January 3, 2018

Ms. Abby Monroe
Coordinating Planner
City of Chicago,
Department of Planning and Development

As a designated consulting party to the National Historic Preservation Act, Section 106 compliance review and the National Environmental Policy Act (NEPA) review underway for Jackson Park, The Cultural Landscape Foundation (TCLF) is pleased to add the following remarks, supporting images, and attachments to the public record. As the Section 106 review is now in the initial phase of identifying historic features that could be adversely affected by the Obama Presidential Center (OPC) and related road closures, we first ask that the Area of Potential Effects (APE) be expanded to include the following:

Fig. 2: The Revised General Plan for Jackson Park, 1895

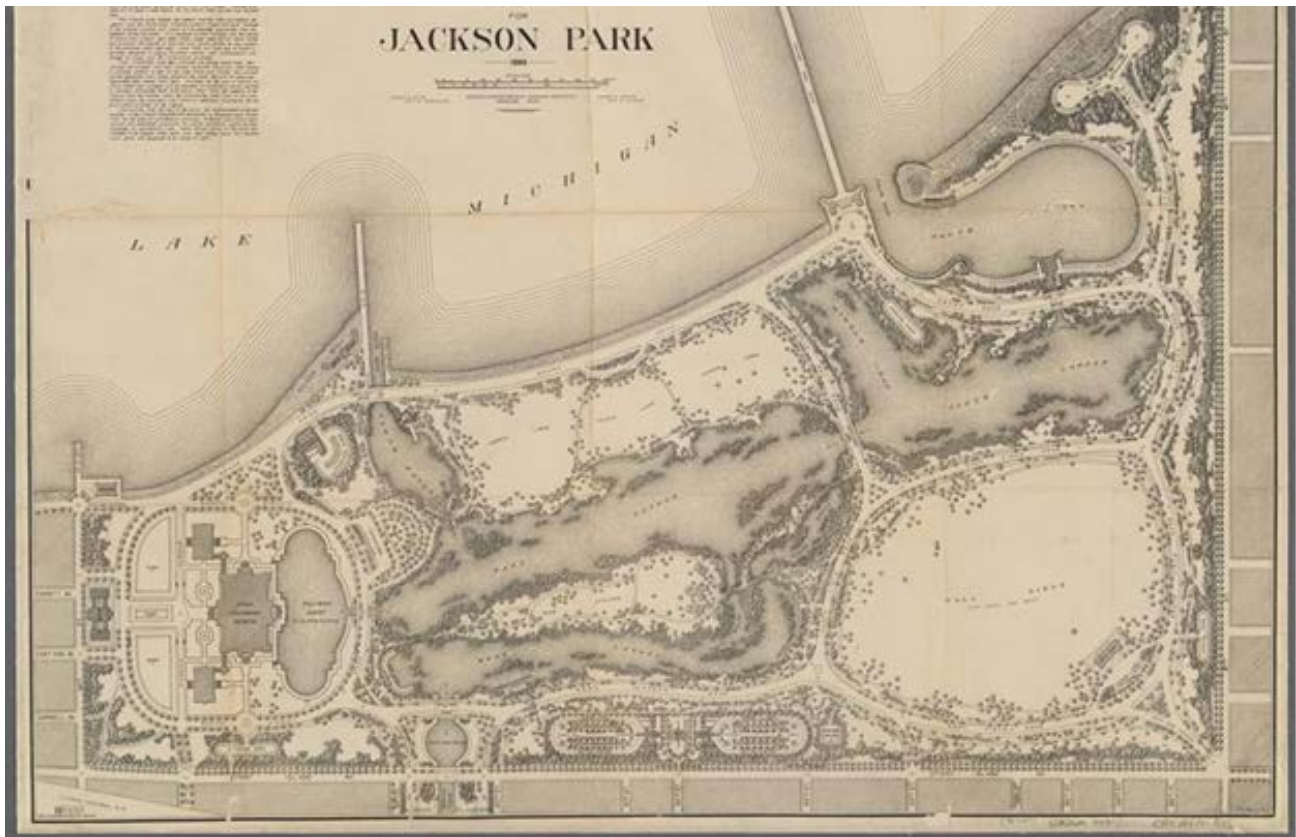
standing in the end. In 1895, Olmsted, Olmsted & Eliot presented a sweeping redesign of Jackson Park that retained “many of the features characteristic of the landscape design of the World’s Fair” while providing “all of the recreative facilities which the modern park should include for refined and enlightened recreation and exercise” (fig. 2).⁴

Although features in Jackson Park have since been modified, the most important aspects of the 1895 plan have endured. Its primary compositional elements—the lake, the fields, and the lagoons—knitted together by a circulation system that affords extended views over relatively level terrain, continue to communicate Olmsted’s vision for how the park is experienced visually and spatially. That assessment was shared by the 2013 GLFER study, which recognized that “for the most part, Jackson Park today looks similar to Olmsted’s 1895 plan in terms of the placement of lagoons, open fields, and areas heavily

Another salient aspect of the 1895 plan that can readily be seen today is the prevailing geometry of the landscape surrounding the campus of the Museum of Science and Industry (then called the Field Columbian Museum) in the park’s northern sector. Notably, the landscape treatment in that part of the park alone was designed to highlight built architecture. Here, Olmsted was unmistakably explicit, stating that the Field Columbian Museum was meant to be the only “dominating object of interest” in the park:
